CONSTRUCTION SUMMARY

Lindsay 2017 Developments Inc. / Sugarwood

Lot/Unit: 60 Phase/Building: 1 Model/Floor Plan: Silver Lake (3702) Elev B 3Bed 2.5Bath

Sketch#1

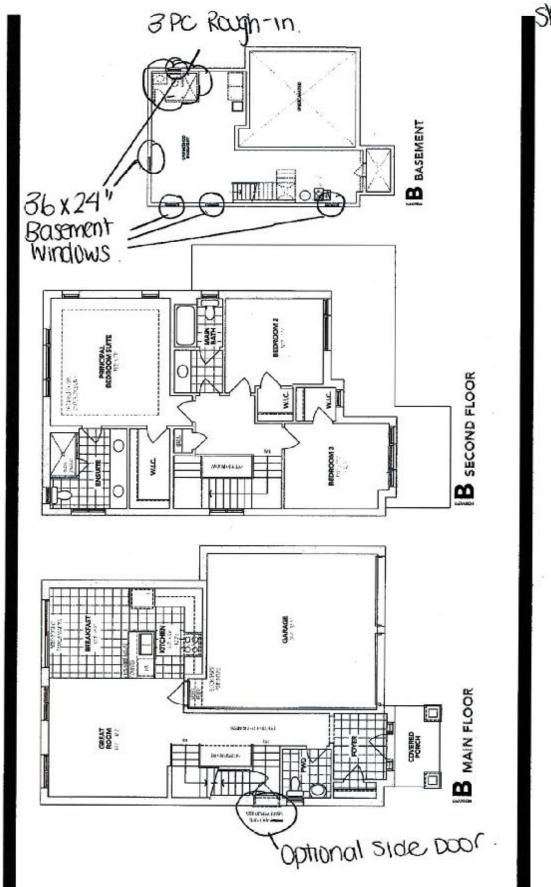
Inv. 5942	1 - To supply and install the optional side door to the side of the house see sketch #1 for details	
Line 75269	Note:	
24Oct22 / 26Oct22		
Inv. 5942	5 - To increase the size of the basement windows to 36x24" in lieu of the standard size see	
	sketch #1 for details	
Line 75270	sketch #1 for details Note: IF UNABLE TO ACCOMODATE PURCHASER WILL BE CREDITED ON CLOSING

Inv. 5942	1 - To supply and install the 3PC Rough-in to the unfinished basement see sketch #1 for details	
Line 75268	Note:	
24Oct22 / 26Oct22
